# UNITED STATES PATENT AND TRADEMARK OFFICE

APPLICATION NO.	FILING DATE	FIRST NAMED INVENTOR	ATTORNEY DOCKET NO.	CONFIRMATION NO.
10/593,174	09/15/2006	Robert Donald Grapes	37261P121	8718

<b>Office Action Summary</b>	<b>Application No.</b> 10/593,174	<b>Applicant(s)</b> GRAPES, ROBERT DONALD	
	<b>Examiner</b> AMENE S. BAYOU	<b>Art Unit</b> 3746

## **DETAILED ACTION**

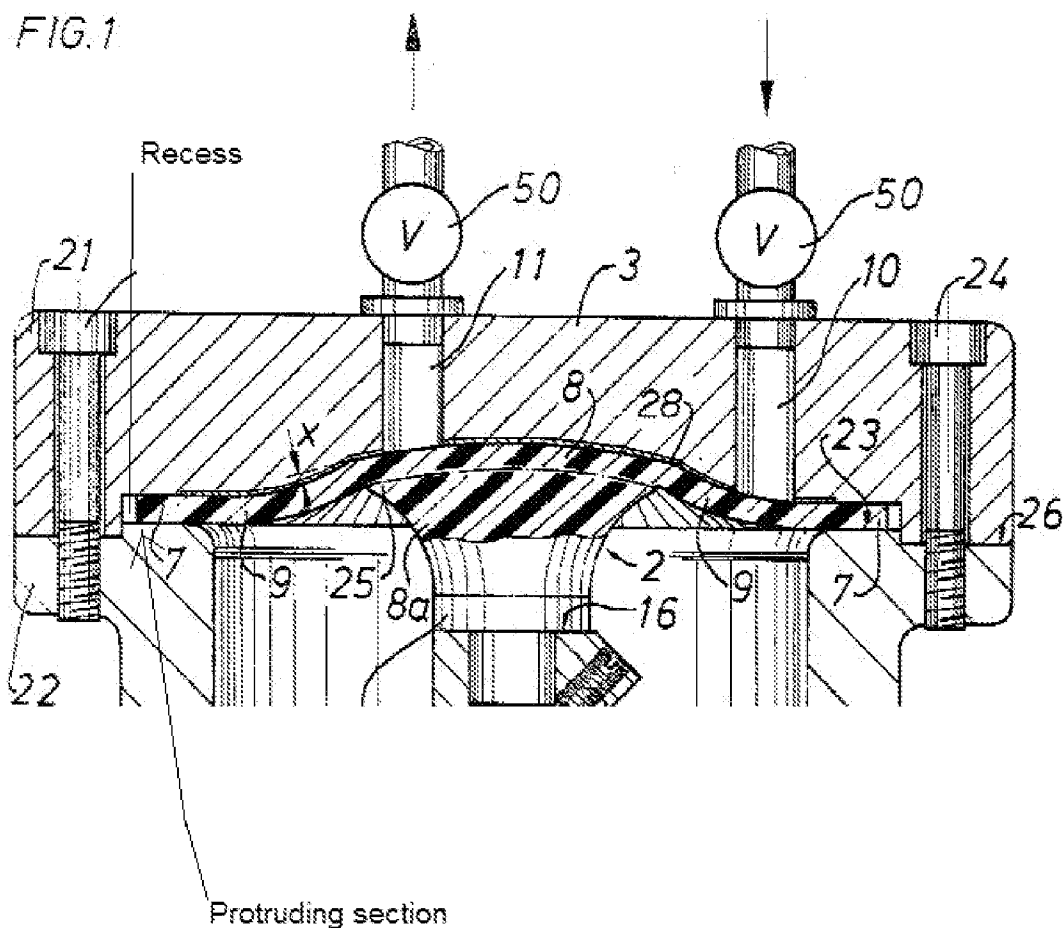
- A pump (1), the second housing section (30) which engages in the recess when the first (10) and second housing (30) sections are combined together, to cause the membrane (20) to be clamped in place, in figure 1 and 2.

But, Behringer et al'096 fails to disclose:

- The second housing section includes a protruding portion

However, Becker'156 teaches a diaphragm pump including:

- The second housing section (k) includes a protruding portion (as shown below), in figure 1.

22. It would have been obvious to one having ordinary skill in the art at the time the invention was made to modify the diaphragm pump of Behringer et al'096 by making protrusion in the second housing section as taught by Becker'156 in order to have better clamping capability.
